**PLANNED UNIT DEVELOPMENT
& SUBDIVISION STAFF REPORT****Date: February 15, 2007**

<u>DEVELOPMENT NAME</u>	Elmore Family Properties
<u>SUBDIVISION NAME</u>	Elmore Subdivision
<u>LOCATION</u>	3222 Spring Hill Avenue (North side of Spring Hill Avenue, 280'± West of Western Drive)
<u>CITY COUNCIL DISTRICT</u>	District 1
<u>PRESENT ZONING</u>	B-3, Community Business District
<u>AREA OF PROPERTY</u>	1 Lot/1.8± acres
<u>CONTEMPLATED USE</u>	Planned Unit Development Approval to allow multiple buildings on a single building site.
<u>TIME SCHEDULE FOR DEVELOPMENT</u>	Existing development, no additions proposed.
<u>ENGINEERING COMMENTS</u>	Must comply with all storm water and flood control ordinances. Any work performed in the right of way will require a right of way permit.
<u>TRAFFIC ENGINEERING COMMENTS</u>	Driveway number, sizes, location and design to be approved by Traffic Engineering and conform to AASHTO standards.
<u>URBAN FORESTRY COMMENTS</u>	Property to be developed in compliance with state and local laws that pertain to tree preservation and protection on both city and private properties (State Act 61-929 and City Code Chapters 57 and 64).

SITE PLAN

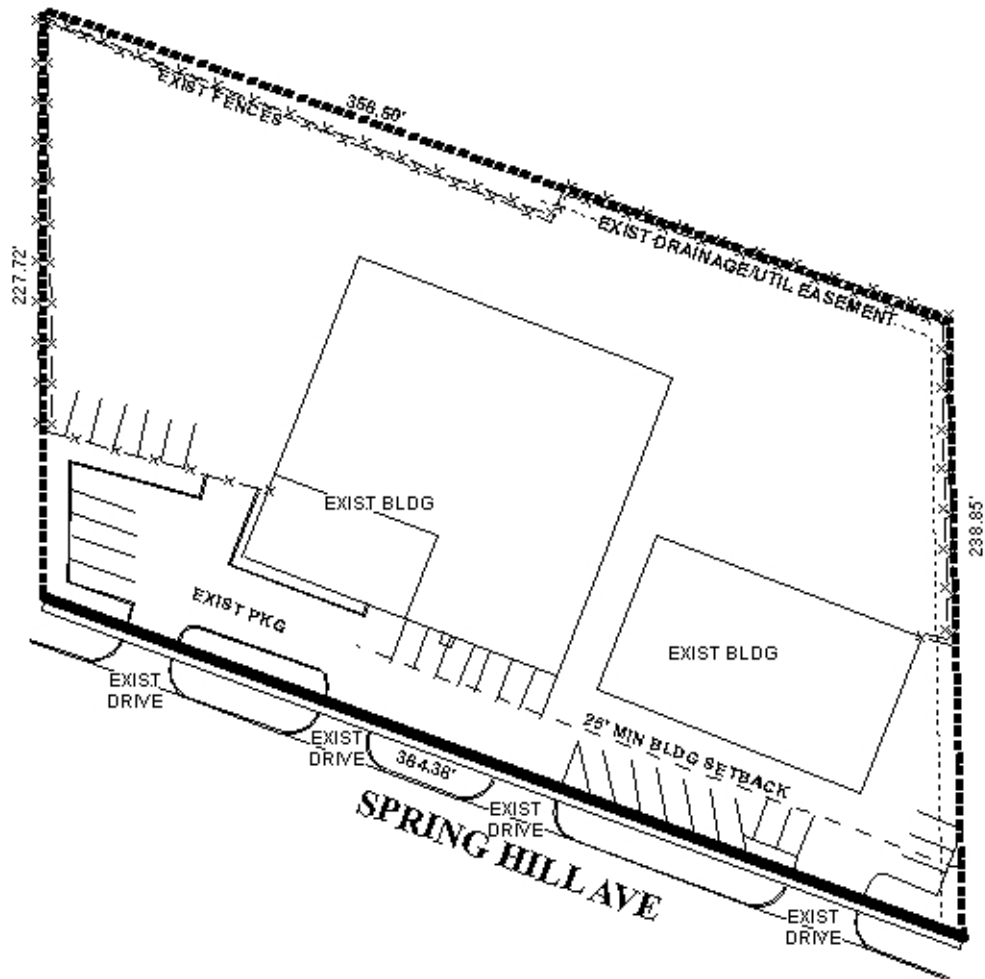
Access management is a concern due to the four existing curb cuts along approximately 365-feet of road frontage along Spring Hill Avenue. The reduction of the existing number of curb-cuts to three and the reworking of the parking area within the front of the development to allow a consistent vehicular circulation should be required. In addition, any changes to the size, design and location of the curb-cuts must be approved by Traffic Engineering, and conform to AASHTO standards.

Parking within the development meets the minimum requirements of the Zoning Ordinance; however, the maneuvering within the site should be redesigned to compensate for the reduction of curb cuts as suggested previously.

The 25-foot minimum building setback line, required in Section V.D.9. of the Subdivision Regulations, is not shown on the complete subdivision plat or site plan.

No trees or landscaping are depicted on the site plan, however compliance to the greatest extent feasible with the tree and landscaping aspect of the Zoning Ordinance will be required. The site plan should be revised to reflect proposed landscaping and any existing or proposed street trees, and compliance with the Zoning Ordinance should be coordinated with Urban Forestry. It should be noted that this site is existing, which may make full compliance with the tree and landscaping requirements impossible.

There is no indication on the site plan as to the proposed location of any dumpster or other waste storage facility. The location of the storage area for the dumpster must be indicated on the site plan, and the location and required screening comply with Section 64-4.D.9. of the Zoning Ordinance, as well as with all other applicable regulations.

Planned Unit Development: Based on the preceding, this application is recommended for Approval, subject to the following conditions: 1) revision of the site plan to depict compliance, with the tree and landscaping requirements of the Zoning Ordinance, to be coordinated with Urban Forestry; 2) depiction of any dumpster or waste container storage location on the site plan; 3) approval of Traffic Engineering regarding the size, design location of any reduction of the existing curb-cuts onto Spring Hill Avenue; 4) completion of the Subdivision process; and 5) full compliance with all municipal codes and ordinances.

Subdivision: Based on the preceding, the plat is recommended for Tentative Approval subject to the following condition: 1) the placement of a note on the final plat stating that the site is limited to three curb-cuts to Spring Hill Avenue, with any changes to the size, design and location of the curb-cuts to be approved by Traffic Engineering, and conform to AASHTO standards; 2) the placement of the 25-foot minimum building setbacks on the Final Plat; 3) provision of a revised PUD site plan to the Planning Section of Urban Development, prior to the signing and recording of the final plat.
